Final Plat
SUBDIVISION REPORT

SUBDIVISION COMMITTEE
METROPOLITAN AREA
PLANNING COMMISSION

S/D No.: 84-23 Name: SYCAMORE VILLAGE 4TH ADDITION

Re: S/D 84-23 - Final Plat of Sycamore Village 4th Addition

FINAL PLAT OF SYCAMORE VILLAGE 4TH. ADDITION

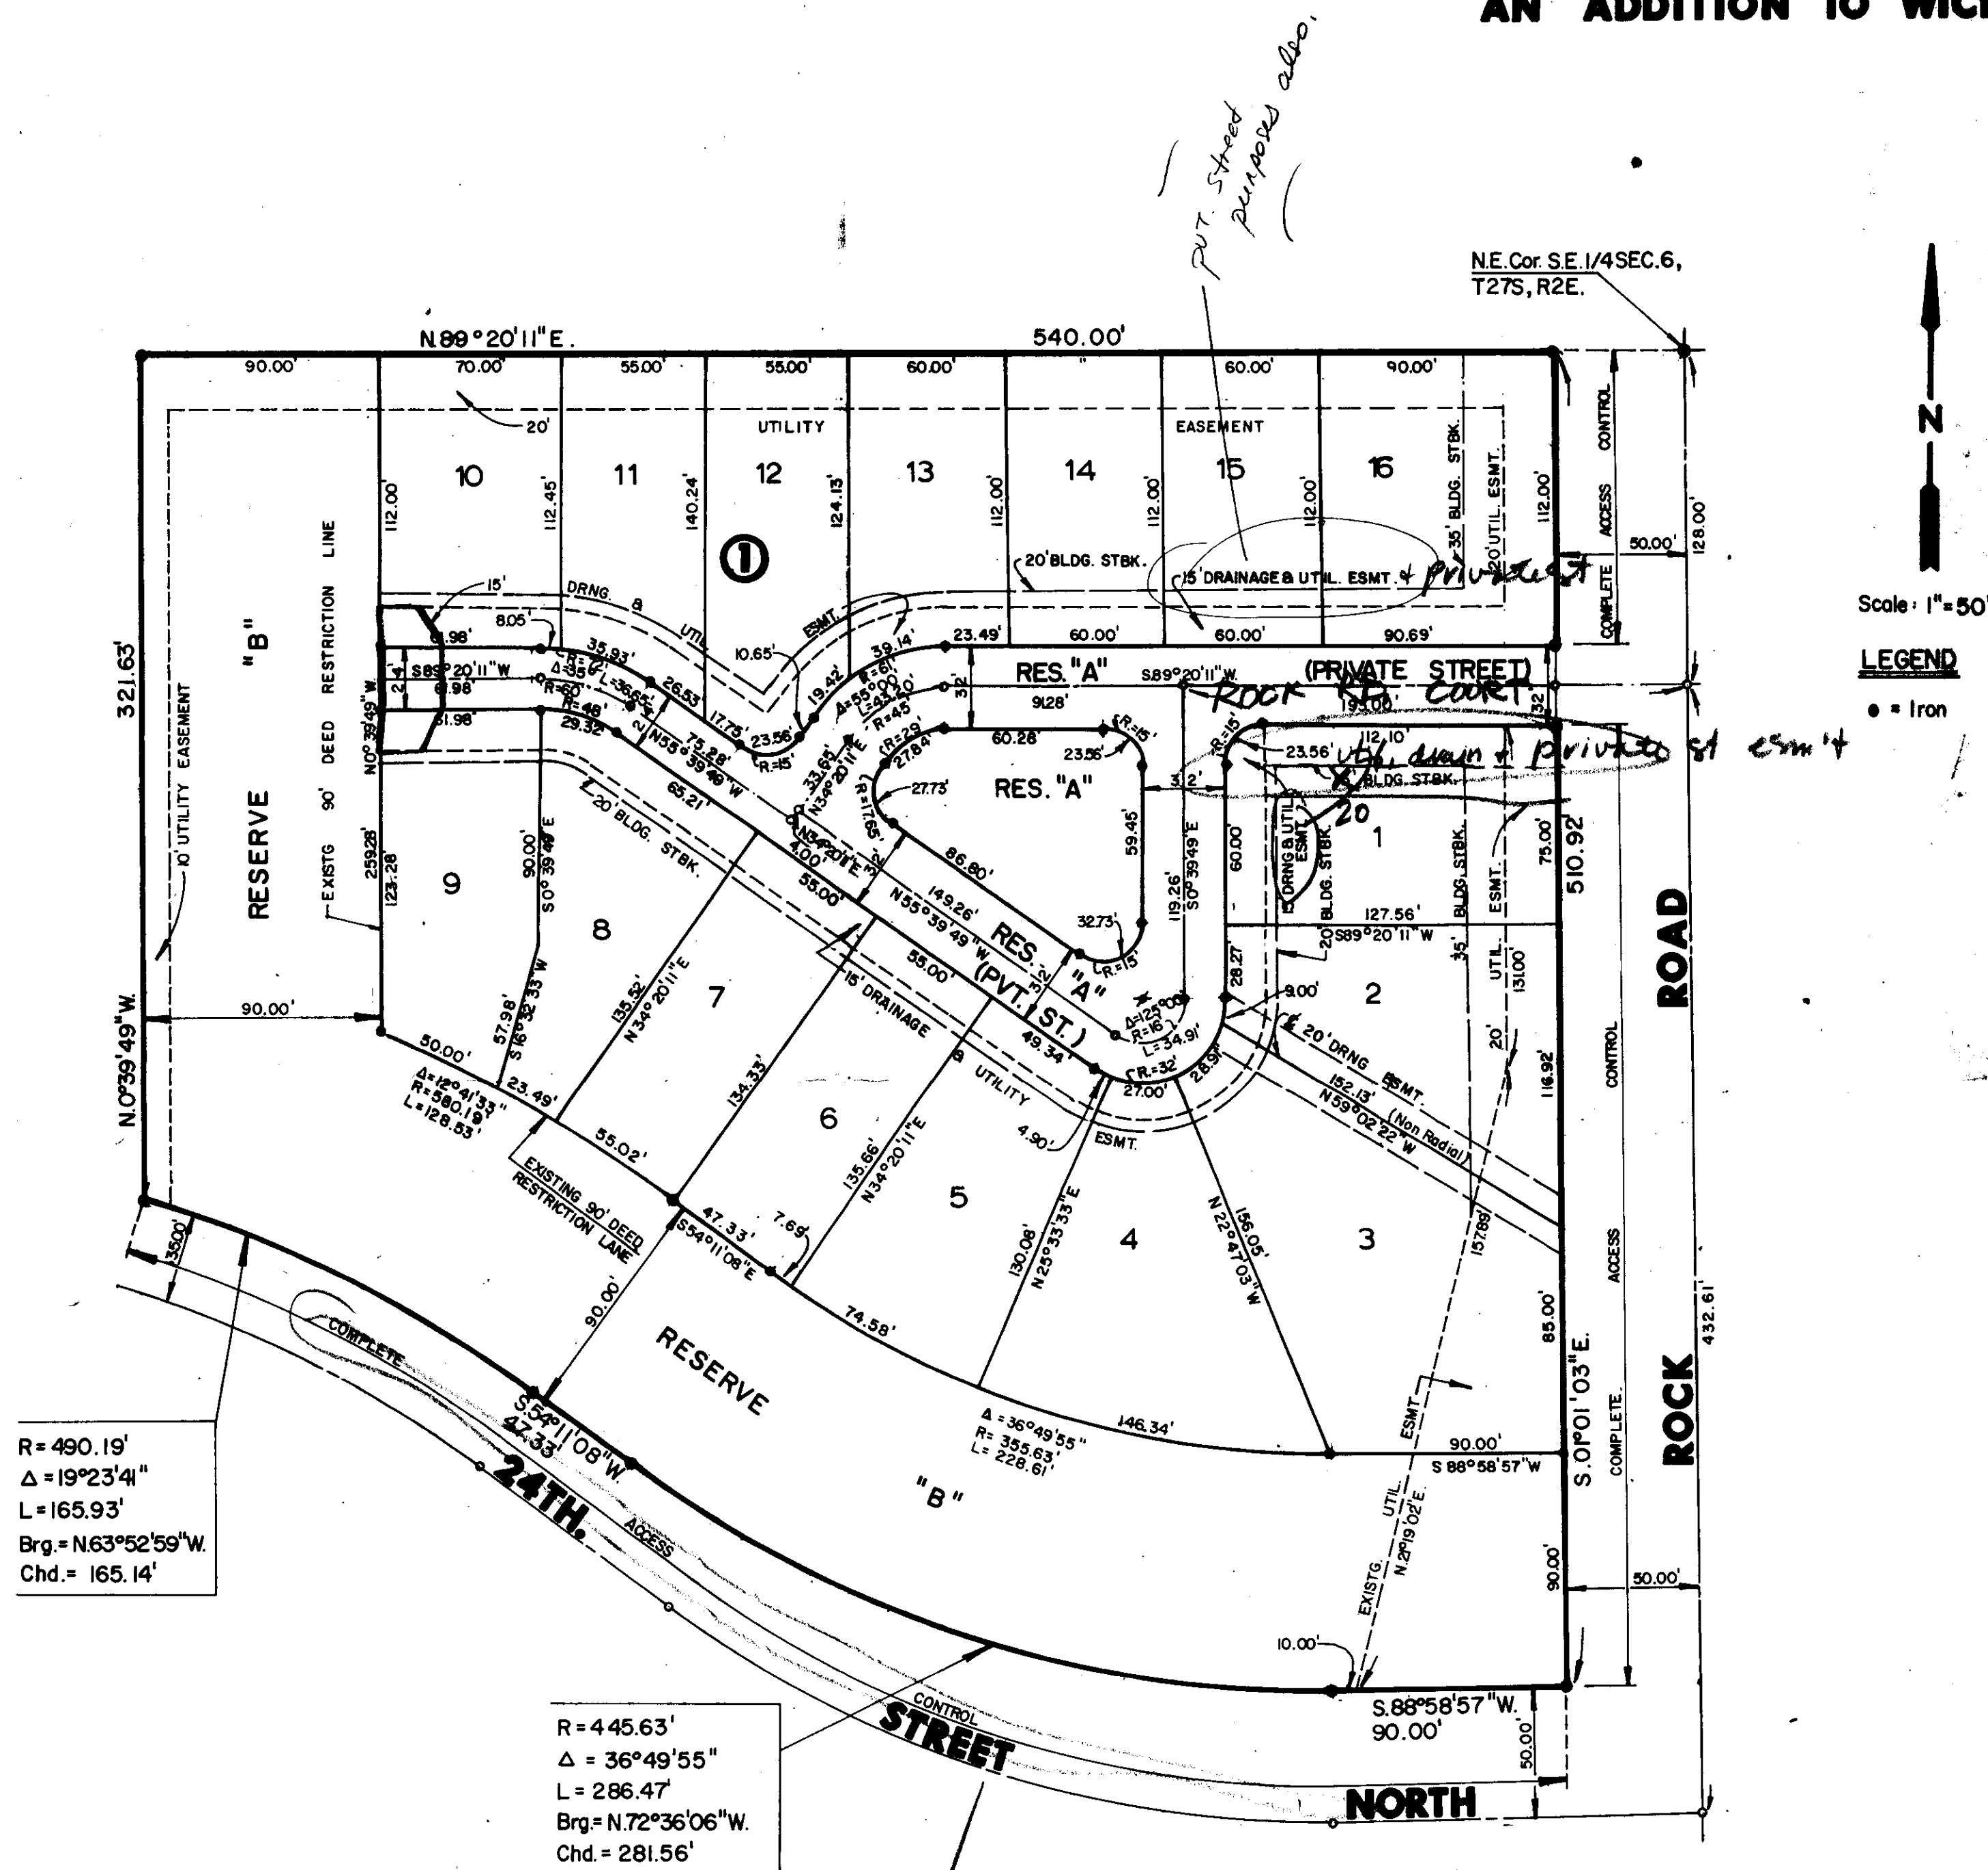
- L. The applicant shall submit the standard avigational easement and restrictive noise covenant for this entire property.
- M. On the final plat tracing, a 15-foot utility, drainage and private street easement shall be indicated adjacent to the north line of Lot 1, Block 1.

- N. On the final plat tracing, the legal description in the engineer's text shall be corrected to reference that this is a replat of Lot 10, Block 4, Sycamore Village 3rd Addition, not Sycamore Village 4th Addition.

- O. On the final plat tracing, the platlor's text shall be amended to reference the platting of "complete access control" to 24th Street North across the south line of this plat.

- P. The final plat tracing shall indicate a 20-foot building setback on Lot 1, Block 1 from that lot's north line. This is needed in order to maintain at least a 5-foot separation between the future building and the drainage and private street easement. This will allow landscaping along the north wall of the future building.

- F. The final plat tracing shall indicate a hammerhead turnaround for the deadend street shown on the preliminary plat.
- G. Provisions will need to be made for ownership and maintenance of the Reserves. The applicant shall either form a homeowners' association prior to recording the plat or shall submit a covenant stating when the association will be formed, when the reserves will be deeded to the association and who is to own and maintain the reserves prior to the association taking over these responsibilities.

- H. On the final plat tracing, the labeling of the 15-foot easement adjacent to the outside of Reserve "A" shall be corrected to read "15-foot utility, drainage and private street easement."

- I. The final plat tracing shall label the name of the proposed private street as "Rock Road Court."
- J. The applicant shall submit a covenant requiring four (4) off-street parking spaces per dwelling unit in this plat.
